From: Feeney, John M - DNR
Sent: Thursday, November 17, 2016 10:48 AM
To: 'Nicole L. LaPlant'
Subject: RE: Former Quality Cleaners, Grafton, WI - BRRTS #02-46-560212

**PROPOSED MONITORING WELL AND
PIEZOMETER LOCATIONS**

FIGURE 3

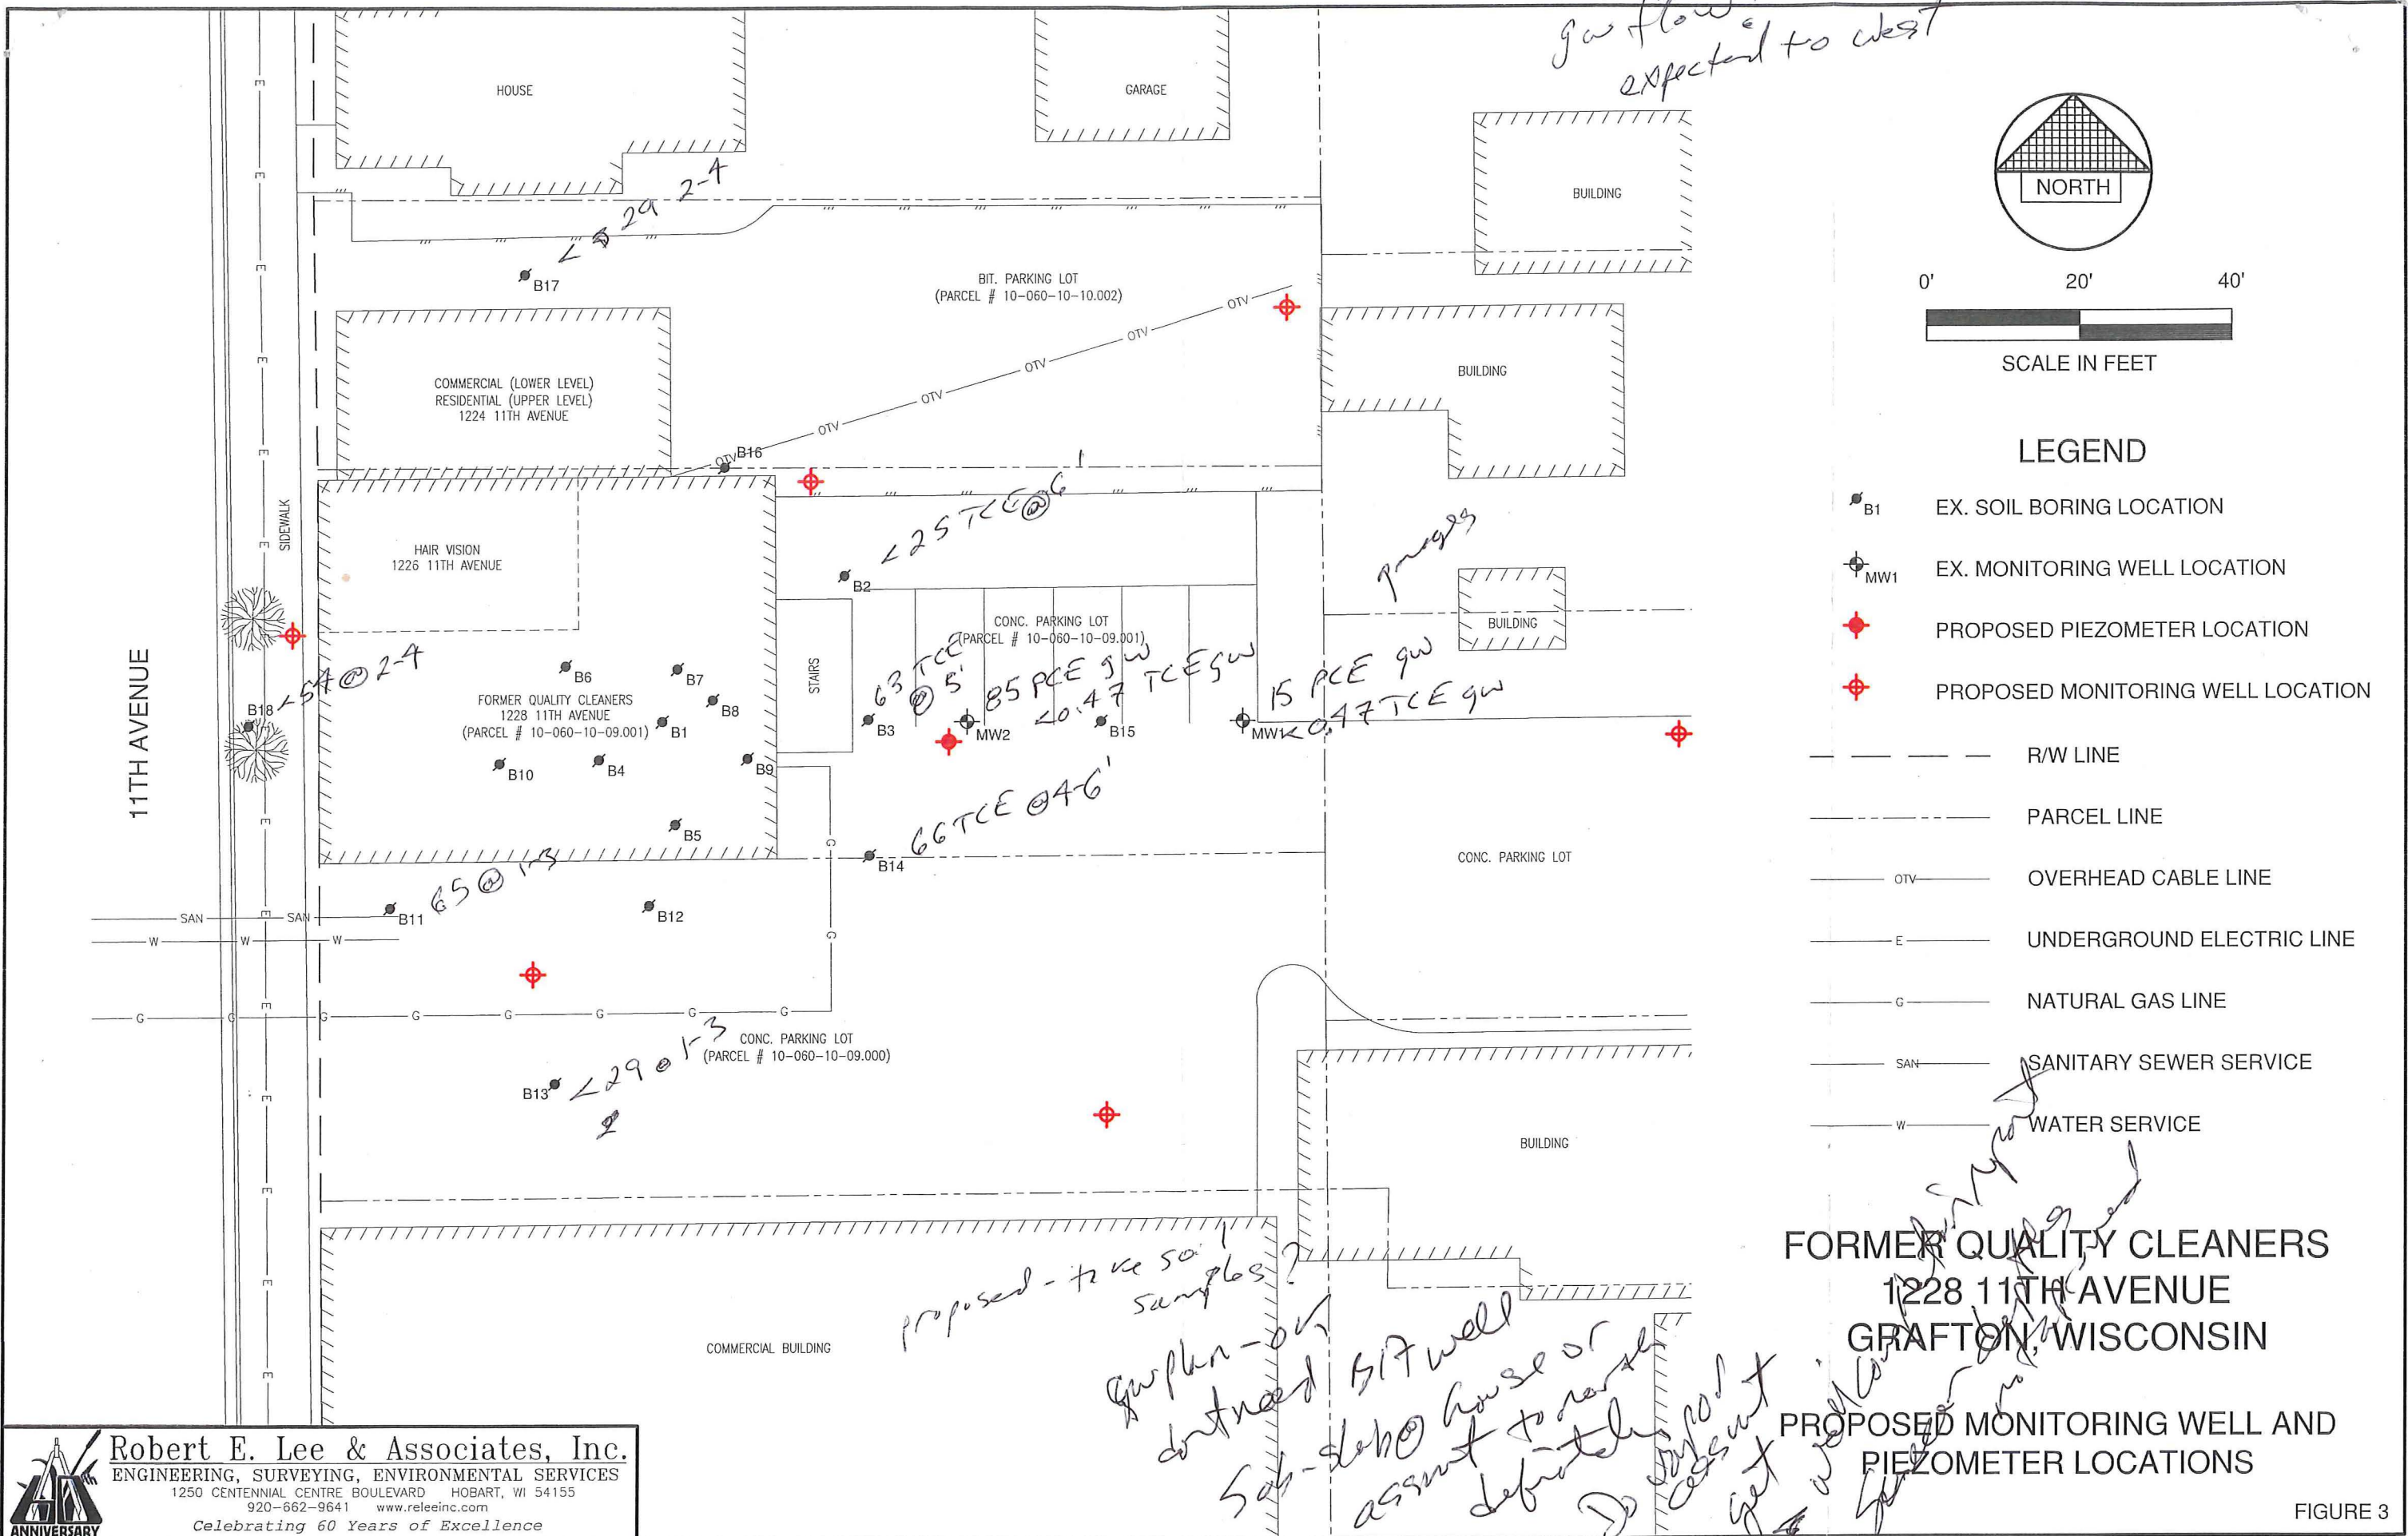
- Submit well construction forms for the Moraine wells. We are not approving your screen intervals without this information.
- As you know, a vapor intrusion analysis of surrounding receptors will be required after you get the new wells in.
- Submit the testing results for the sub-slab samples in the adjacent building (I can check my email archive for it if you prefer to wait).

gas flow expected to west

*proposed - to see soil samples?
gas plan - on dirt road - on Sab - slope house or adjacent to north side of road*
